PUBLIC UTILITIES COMMISSION OF THE STATE OF CALIFORNIA

Agenda ID# 24510
RESOLUTION E-5476
October 8, 2026

Resolution E-5476. Adopts updates to the Avoided Cost Calculator for use in demand-side distributed energy resource cost-effectiveness analysis.

Figure 2

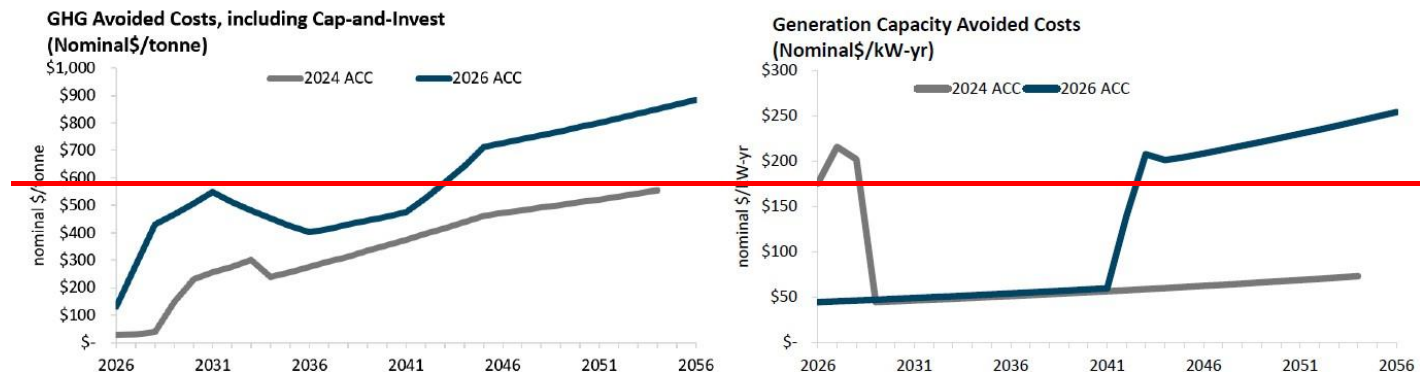
CLECA contends that the draft Resolution misrepresents the volatility of generation capacity avoided costs, stating that costs fall 85 percent from 2026 to 2027, rise 308 percent in 2028, fall 74 percent in 2029, and increase 744 percent between 2040 and 2045. CLECA contends that these swings persist even with the floor binding in most years from 2027 through 2040 and argues that absent the floor, volatility would be greater, indicating model instability. CLECA further states that because the Resolution adopts the 2026 ACC v1a and presents generation capacity results only in Figure 2, that figure should be corrected before adoption.

In its Opening Comments, SEIA contends that Figure 2 in Draft Resolution E-5476 does not reflect the correct IC model results and contends that the proper figure appears on the IC model's "Result Summary" tab.

Energy Division acknowledges the Draft Resolution Figure 2 misrepresented capacity avoided costs. The comparison of capacity avoided costs and allocation factors between 2024 ACC and 2026 ACC can be found in the ACC documentation section 4.4 and 4.5.

Energy Division notes the comparison of capacity avoided costs and allocation factors between 2024 ACC and 2026 ACC can be found in the ACC documentation section 4.4 and 4.5.
